PCN:	GT 150 FEMALE SN SEALED localization

Subject:	GT 150 FEMALE SN SEALED localization

Date:	October 26,2026

Before Change:	
After Change:

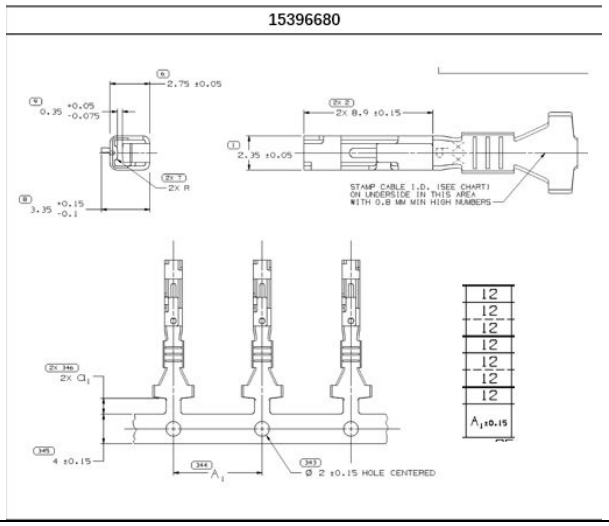
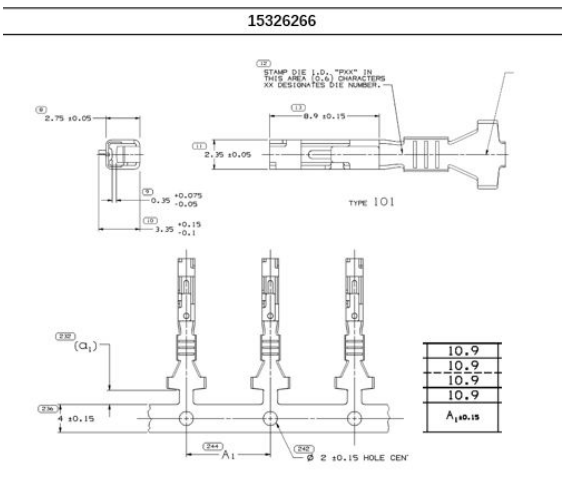
Description :	DCS Shanghai Plant has completed GT 150 SN SEALED localization. Domestic PN is 15326266.
Assessment of Change:	Terminal body dimensions are completely identical, spacing of the terminal reels is different,15396680 is 12mm,15326266 is 10.9mm.

15396680	15326266

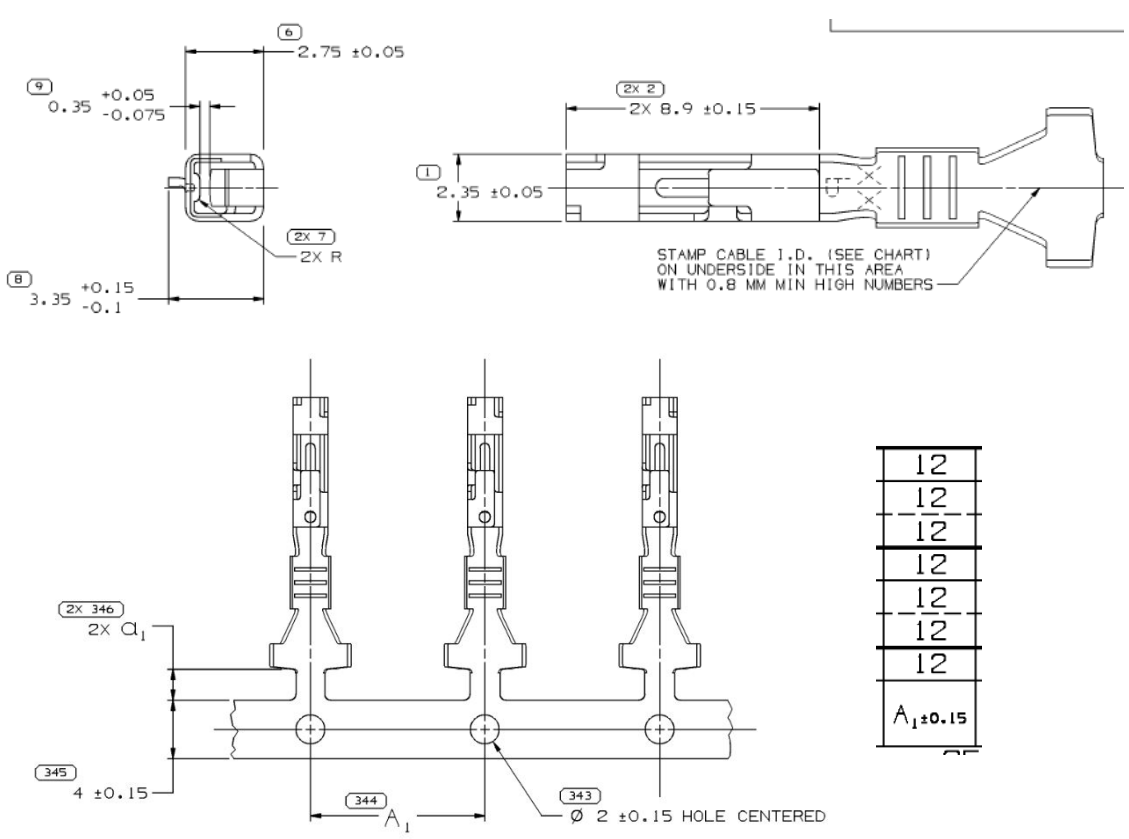
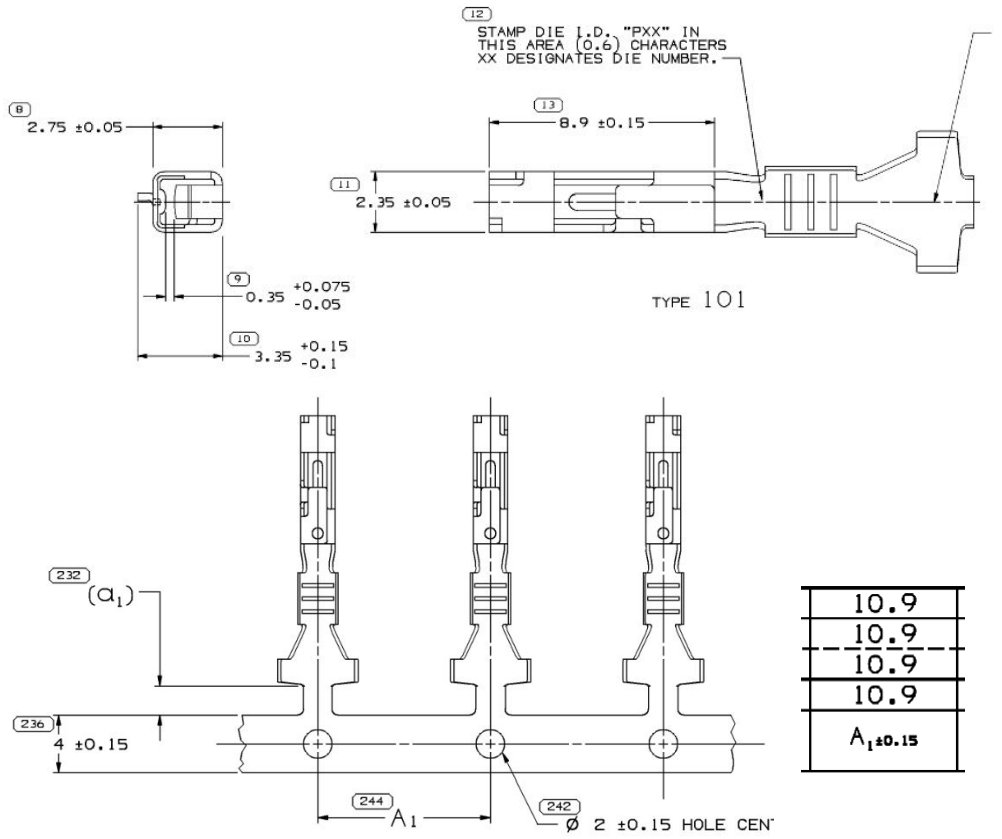
端子本体尺寸完全相同，唯一区别是端子绕盘间隔不同，一个是12mm，一个是10.9mm
